BIDDING AND CONTRACT REQUIREMENTS
ADDENDUM NUMBER 02

Date: 8/17/2026

Architect's Project Number:
226057.00

Re: **Addendum Number 02 to the bidding documents for:**
Moline-Coal Valley School District
Moline High School – Baseball & Softball Complex Renovation

TYPICAL OUTFIELD CROSS SECTION
NOT TO SCALE

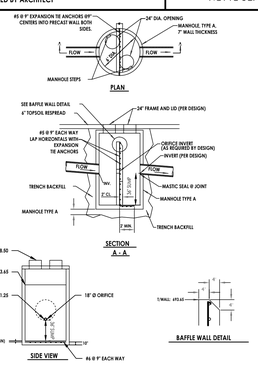
A. Drawing C-7.1, titled, CONSTRUCTION DETAILS
   1. Updated Typical Outfield Cross Section Detail
   2. Refer to the attachments for clouded revisions.

8/14/2026	29	Bush Sports Turf	In alternate #1, it states to have natural grass with drainage and irrigation that matches the 2 JV fields. Are they also wanting to have the infield skin and warning track switched to natural or left synthetic? Are they wanting 3" of sand tilled in? Where is the cut off line for the natural, at the field fence edge? Are the bullpens, batting cage and soft toss area next to the varsity baseball field staying synthetic?	2	The infield skin and warning track are also to be switched to natural grass. The alternate bid for the two varsity fields includes changing the entire field of play area from synthetic turf to a natural grass/dirt playing surface. Refer to the attached updated AS001 for clarification. Under the alternate bid, the batting tunnels, soft toss area, and area adjacent to the visitor bullpen are to still receive synthetic turf.
8/14/2026	30	Bush Sports Turf	On sheet C-3.2, it states that 3" of USGA sand is to be tilled into 6" of native soil. On sheet C-7.1, there is a detail that shows 4" of pea gravel beneath the tilled rootzone. Could there be clarification on which is correct?	2	This detail has been updated and now shows only the sand being tilled into the native soil. The pea gravel has been removed. Refer to the attached updated C-7.1 for clarification.

8/14/2026	31	Bush Sports Turf	On sheet C-7.1, there is a detail that shows a 4" PVC perforated draintile. On C-5.2, it is called out for 2" ADS turfflow. Could there be clarification on which is correct? Are the 2" Turfflow drainlines to have sand channels all the way to the surface?	2	This detail has been updated to now note the perforated draintile generically and to refer to the plan. Intent is to follow what is noted on C-5.2.
8/16/2026	32	Bush Construction	I just wanted to clarify that note NS023 that says "Owner provided aluminum bleachers systems" on AS001 means they are purchasing and installing them so we are not including any costs for bleachers in our bids, is that correct?	2	Note has been udpated to read, "Owner provided aluminum bleacher systems. Contractor installed."
8/17/2026	33	Bush Construction	With the alternate to provide natural turf at the varsity field am I to assume that the curb would be deducted everywhere?	2	Concrete curb will still be required for the areas around the batting tunnels, future soft toss area, and area around the visitor bullpen at the varsity baseball field. See the attached updated AS001 for clarification.

1 E-100 ELECTRICAL SITE PLAN

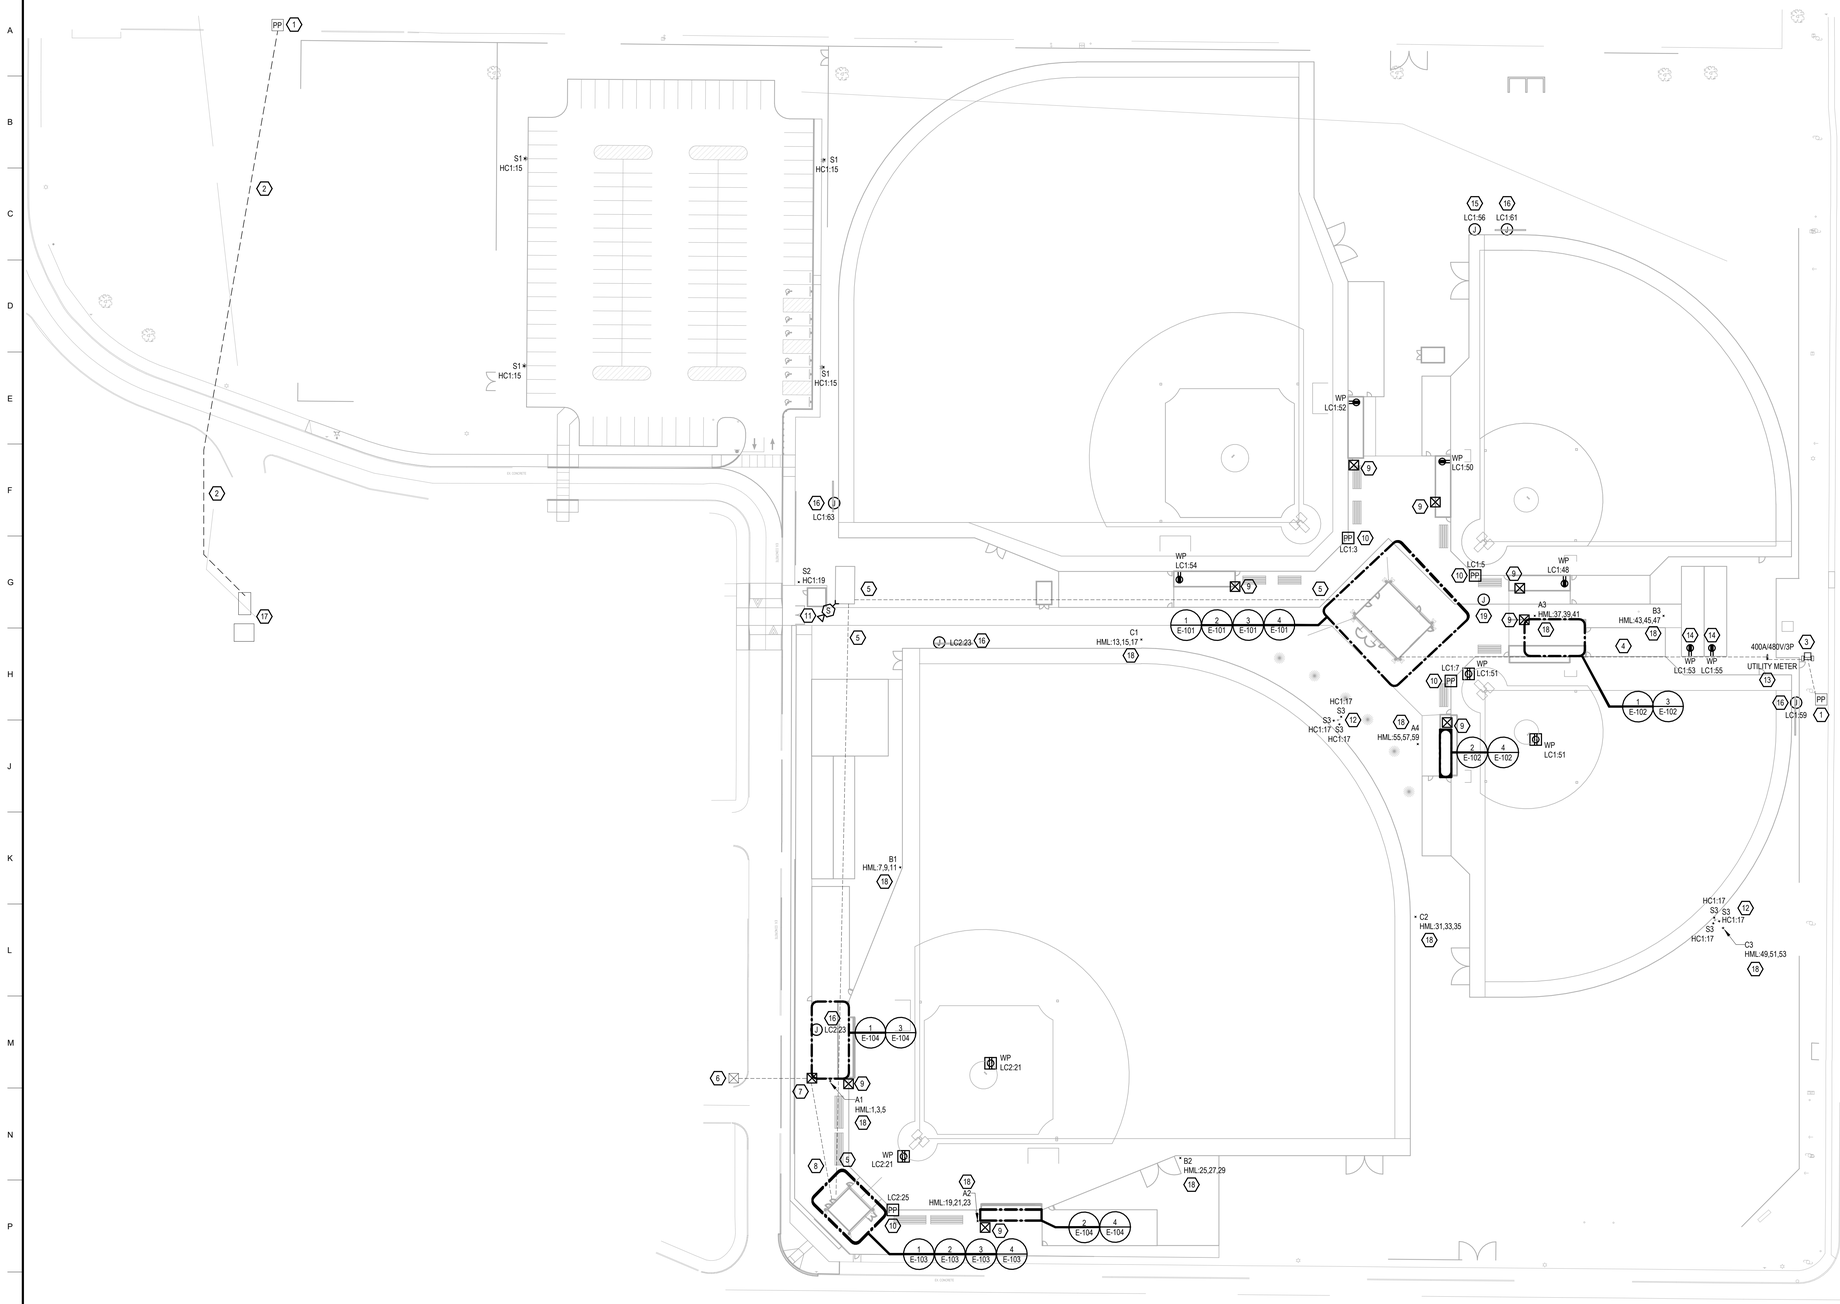
C. Drawing E-100, titled, ELECTRICAL SITE PLAN.
   1. At GENERAL NOTES:
      a. REVISE note 12.
      b. ADD note 14.
   2. At KEYNOTES:
      a. REVISE note 18.

11. ALL LIGHT FIXTURES ARE NEW UNLESS SPECIFIED OTHERWISE.
12. EC TO PROVIDE 1" SCHEDULE 40 PVC CONDUIT WITH MINIMUM #10AWG CONDUCTORS FOR ALL UNDERGROUND SITE LIGHTS. (A1)

13. MUSCO LIGHTING FINAL PLACEMENT, MOUNTING, DISTRIBUTION, AND CONTROLS TO BE COORDINATED WITH MUSCO.
14. UNDER BASE BID, EC TO PROVIDE 1" SCHEDULE 40 PVC CONDUIT TO MUSCO LIGHT LOCATIONS AND HANDHOLE AT MUSCO POLE LOCATIONS. UNDER ALTERNATE BID, PROVIDE MINIMUM #10 AWG CONDUCTORS. EC SHALL VERIFY VOLTAGE DROP WITH FINAL FIELD ROUTING. (A3)

18	UNDER ALTERNATE BID, EC TO INSTALL BALLFIELD LIGHTING SYSTEM PROVIDED BY SCHOOL DISTRICT. APPROXIMATE LOCATION OF MUSCO POLE, POLE BASE, AND FIELD LIGHTING SHOWN. COORDINATE EXACT LOCATIONS WITH MUSCO LIGHTING PRIOR TO INSTALLATION. INSTALL LIGHTING, POLE, POLE BASE, AND REQUIRED EQUIPMENT GROUNDING PER MANUFACTURER'S REQUIREMENTS. REFER TO E-300 FOR ADDITIONAL PRELIMINARY DETAILS. REFER TO GENERAL NOTE 14 (A3) FOR CONDUIT REQUIREMENTS.
19	PROVIDE POWER TO GRINDER PUMP. 2#12 AWG CU + 1#12 AWG EQ GND IN 3/4"C. COORDINATE FINAL ELECTRICAL REQUIREMENTS WITH CIVIL. REFER TO CIVIL DRAWINGS FOR EXACT LOCATION.

3 E-101 ELECTRICAL SECOND FLOOR PLAN - CONCESSION BUILDING

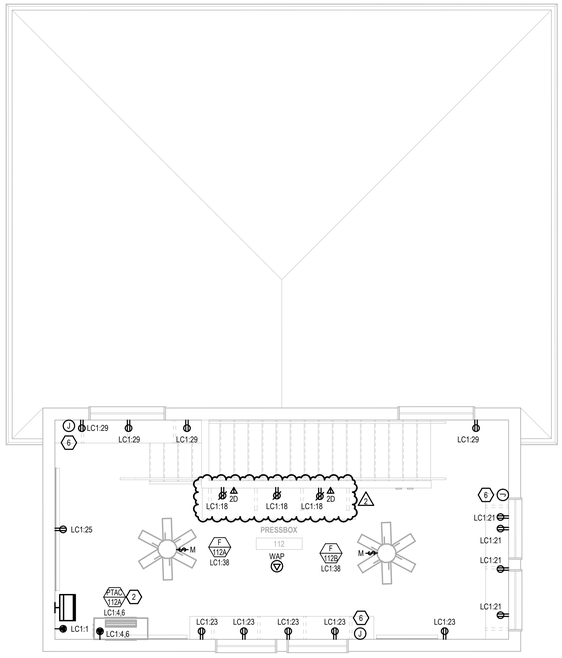
D. Drawing E-101, titled, ELECTRICAL PLANS – CONCESSIONS BUILDING.
   1. At Drawing 3:
      a. ADD power/data at counter near stairs in Pressbox 112.
